STREAMFLOW GAGING PLAN

LICENSE ARTICLE 406

BAKER RIVER PROJECT FERC No. 2150-033

Puget Sound Energy Bellevue, Washington

Figure 1. USGS gages at the Baker River Hydroelectric Project.

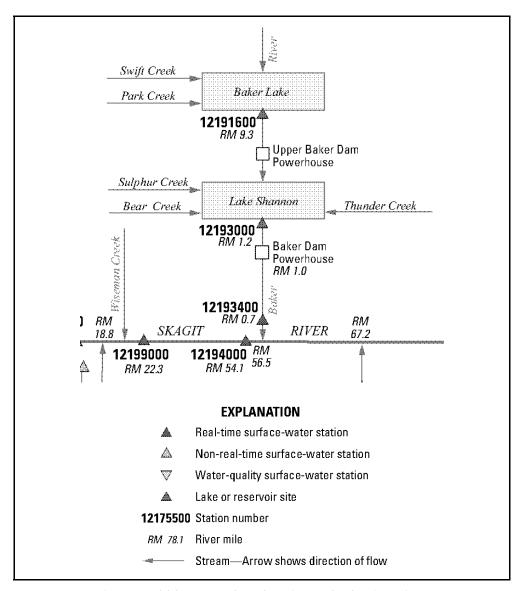
3. It should be noted (perhaps in section 2.0 or 2.3.1) that station 12193400 replaced station 12193500 in May 2009. Then update Figure 1 and section 4.0.	Changes made as suggested.
